**STAFF REPORT
FOR THE PLANNING COMMISSION**

FILE NUMBER: SUB-14-01/VAR-14-01/VAR-14-03/VAR-14-04/VAR-14-05/MISC-14-02

REQUEST: 4-lot subdivision with four Class II Variances and a permit to Enlarge/Alter a Non-Conforming Structure at 1770 Ostman Rd.

STAFF REPORT PREPARED BY: Tom Soppe, Associate Planner

PRELIMINARY SUBDIVISION PLAT WITH BUILDING SETBACKS

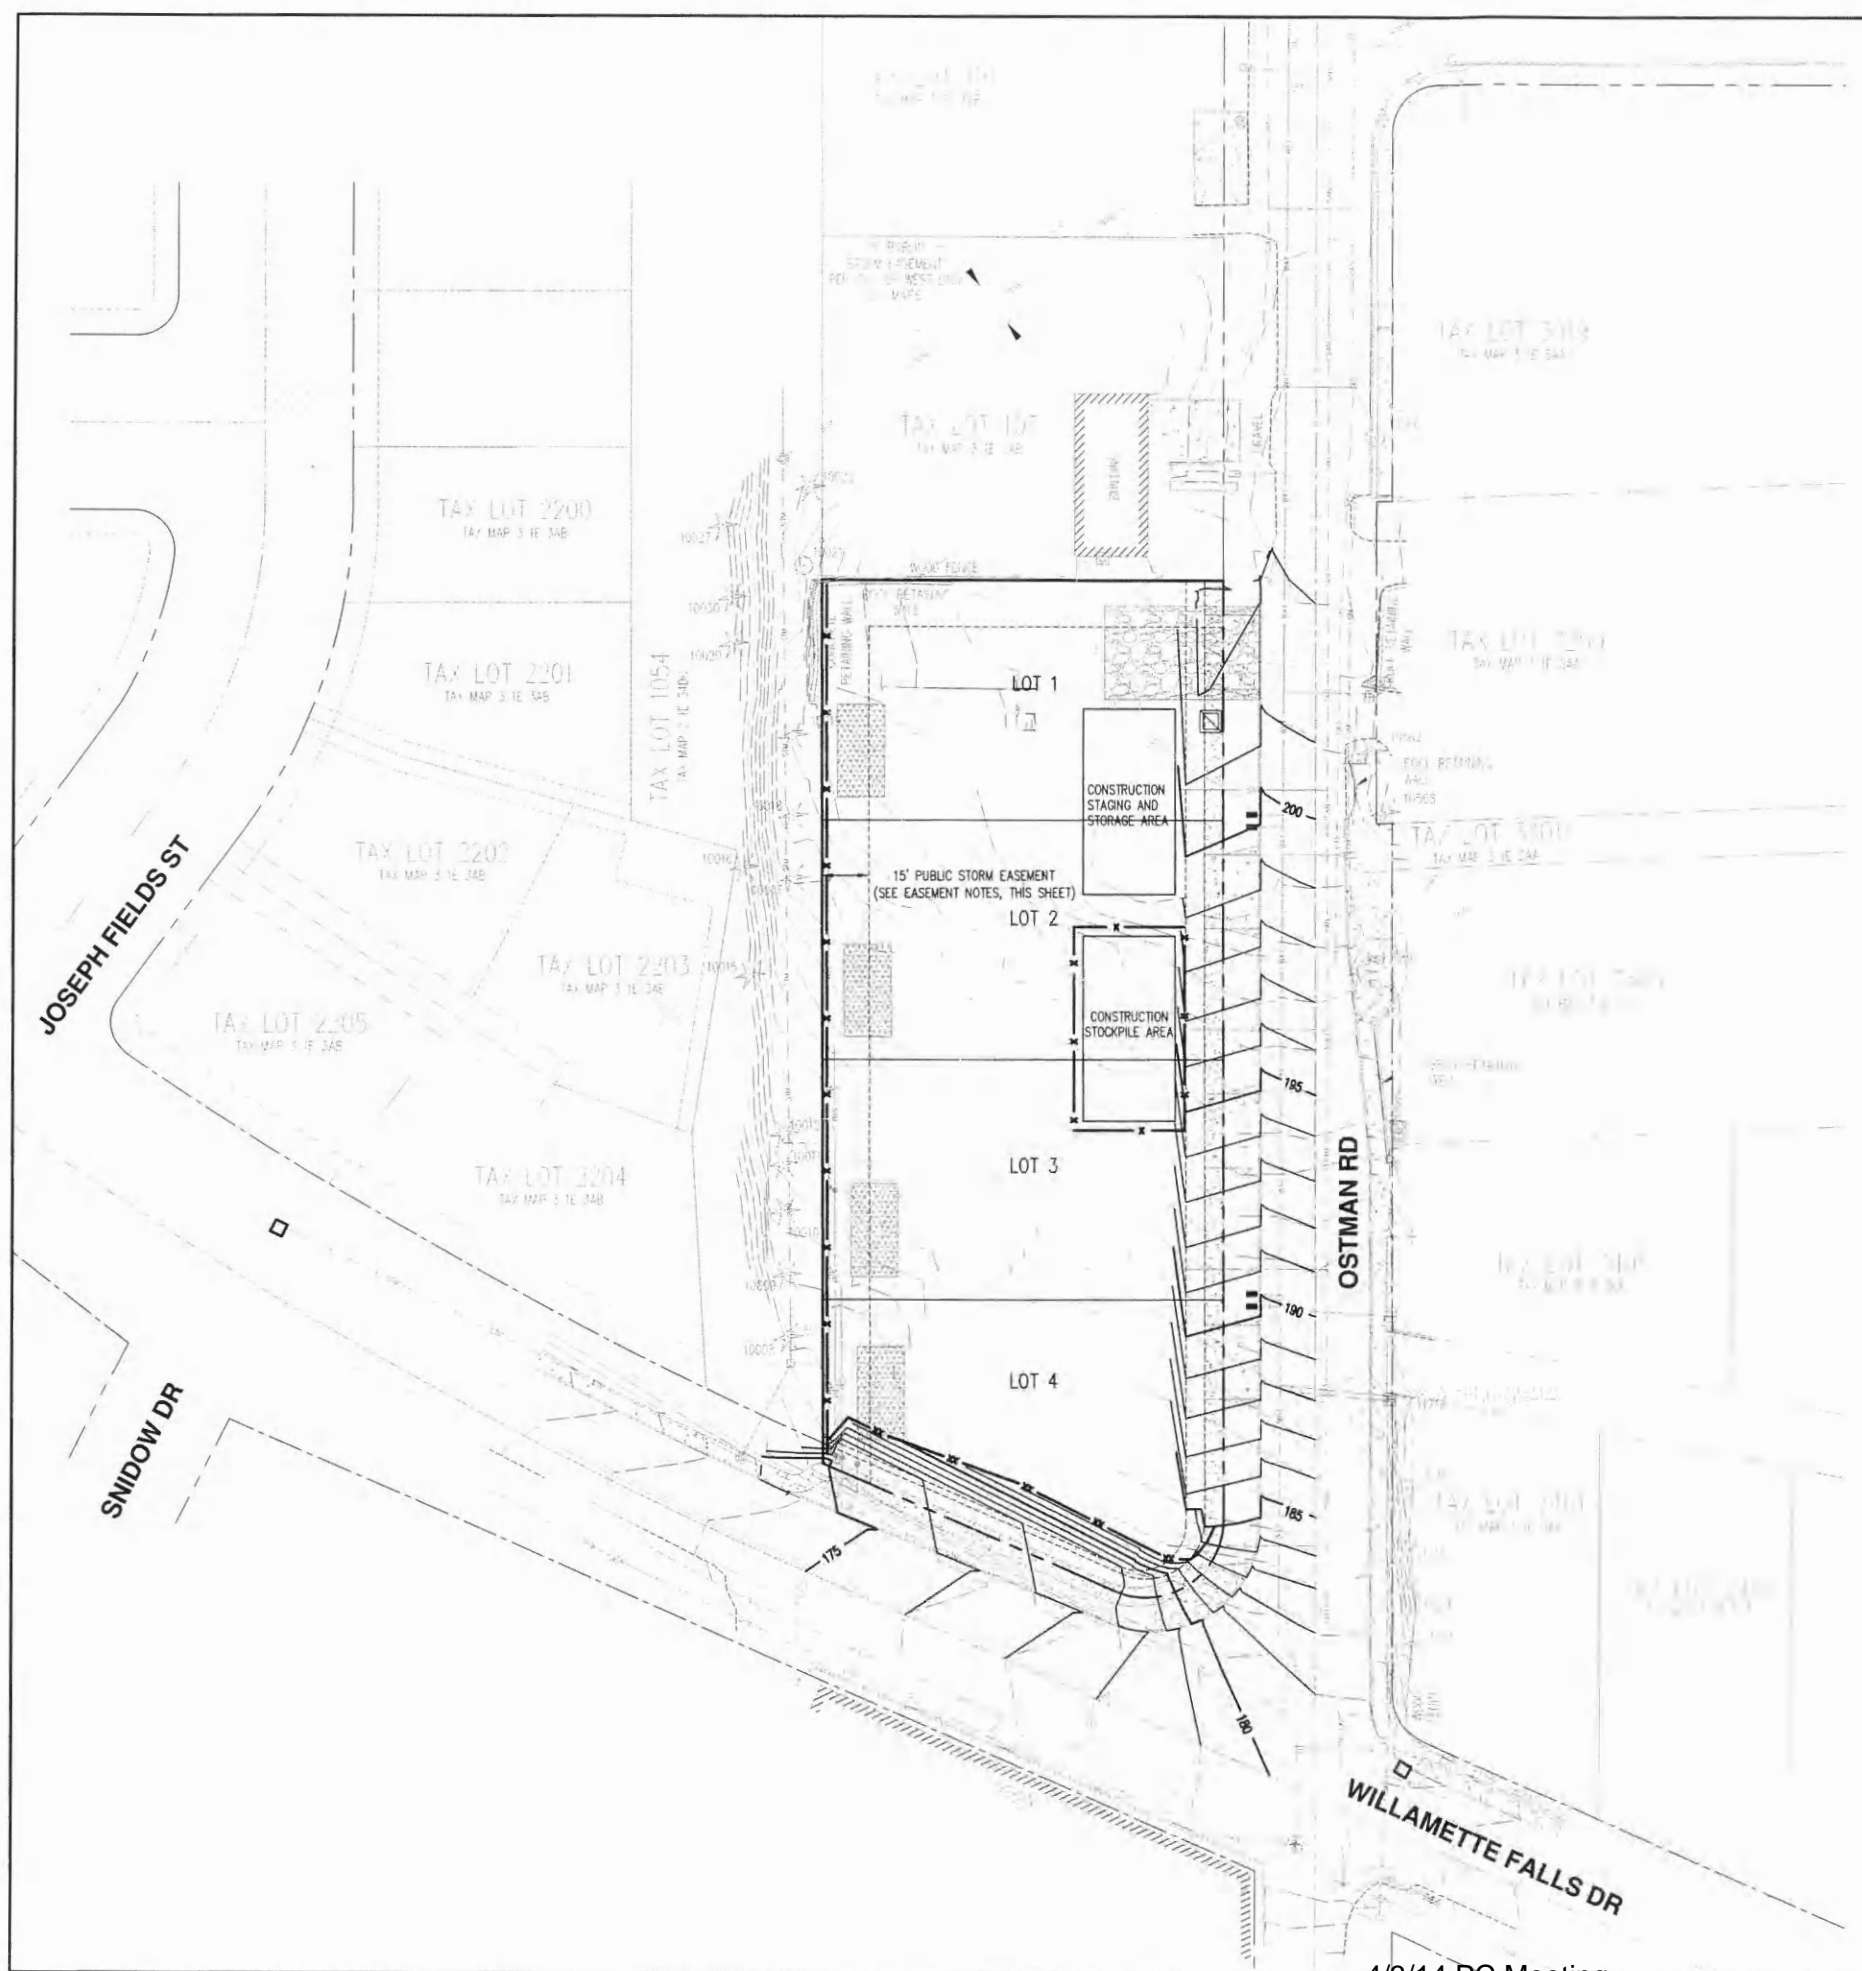
1. **Site Plan.** With the exception of modifications required by these conditions, the project shall conform to the Preliminary Subdivision Plat With Building Setbacks, Sheet 5, dated February 21, 2014, located on Page 50 of Exhibit PC-4.
2. **Sidewalk Along Bus Stop.** The applicant shall widen the sidewalk and the proposed public sidewalk easement to eight feet along the existing bus stop.
3. **Engineering Standards.** All public improvements and facilities associated with public improvements including grading, onsite stormwater design, street lighting, easements, and easement locations are subject to the City Engineer’s review, modification, and approval.

Staff Response 14: Staff has recommended achieving the minimum variance by consolidating the driveways for lots 1 and 2 into one curb cut, and the driveways for lots 3 and four into

another curb cut. See Staff Response 30 below and Condition of Approval 5. Staff determines the criterion is met upon the inclusion of Condition of Approval 5.
